COMMENTS	RESPONSES
<p data-bbox="743 245 926 264">Comment Letter O3b</p> <p data-bbox="270 326 873 561"> <b>Transportation &amp; Traffic Impact  Analysis Report  Neal K. Liddicoat, P.E., Traffic  Engineering Manager,  MRO Engineers Inc.</b> </p> <p data-bbox="298 1084 842 1170"> <b>EXHIBIT A</b> </p>

TABLE 6-3  
EXISTING FREEWAY MAINLINE OPERATIONS

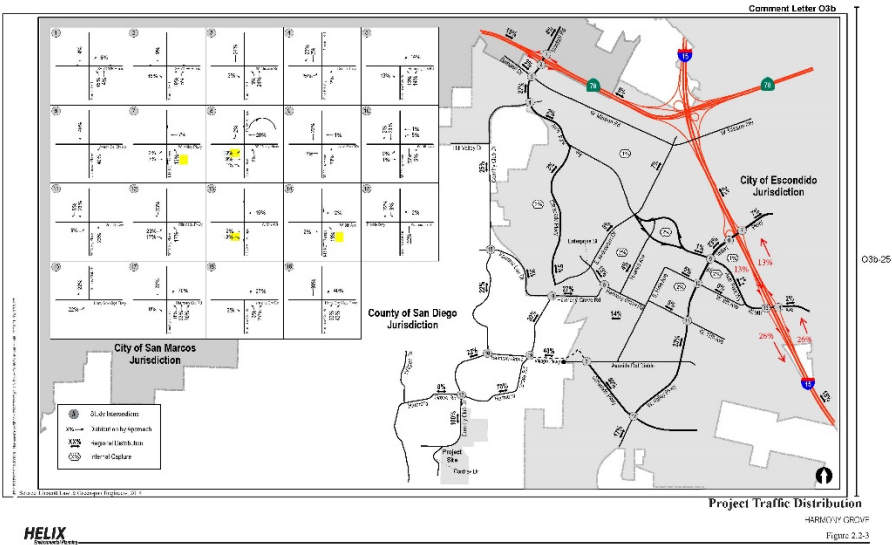
COMMENTS	RESPONSES
<div data-bbox="130 207 262 1406"></div> <div data-bbox="743 240 926 264"><p>Comment Letter O3b</p></div> <div data-bbox="518 548 709 609"><p>ATTACHMENT A CALTRANS PeMS DATA</p></div> <div data-bbox="953 680 1020 704"><p>O3b-24</p></div>	<p><b>Response to Comment O3b-24</b></p> <p>This attachment provides a comparison of the existing baseline traffic volumes used in the Final TIA analysis and recently collected traffic data. The findings from this comparison validate the existing baseline analysis in the Final TIA. Please also see Response to Comment O3b-4.</p>
